15. **Approve Change Order #9 to FC-1142-00/BJC – CR 427, Phase V & VI with Bergeron Land Development, Kissimmee (\$22,949.79 + 61 day time extension).**

SEMINOLE COUNTY, FLORIDA  
CHANGE ORDER FOR CONSTRUCTION PROJECTS

CONTRACT NO: FC-1142-00/BJC INITIATION DATE: 06/23/03  
CHANGE ORDER NO: 09 ACCOUNT NO: \_\_\_\_\_  
CONTRACT FOR: County Road 427, Phase V & VI

SEMINOLE COUNTY CHANGE ORDER # 09  
CR 427 PHASE V & VI  
CONTRACT FOR BERGERON LAND DEVELOPMENT  
CONTRACT NO.: FC-1142-00/BJC

Job \_\_\_\_\_ Project No. \_\_\_\_\_  
Description TRAFFIC SEPARATOR Computed by \_\_\_\_\_  
SQUARE FOOTAGE - Etching Checked by \_\_\_\_\_

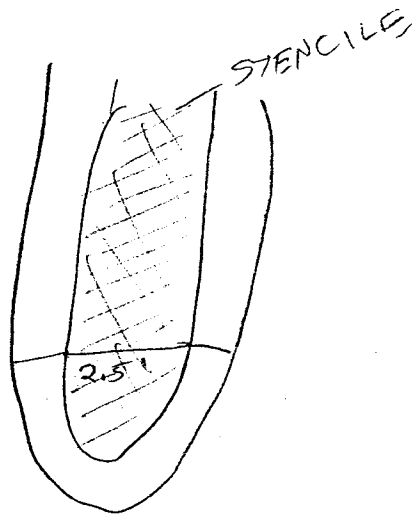
$$(417) \quad 325' \times 2.5' W = 812.5$$

$$121' \times 2.5' W = 302.5$$

$$486' \times 2.5' W = 1215.0$$

$$\text{TOTAL} \quad 2330 \text{ ft}^2$$
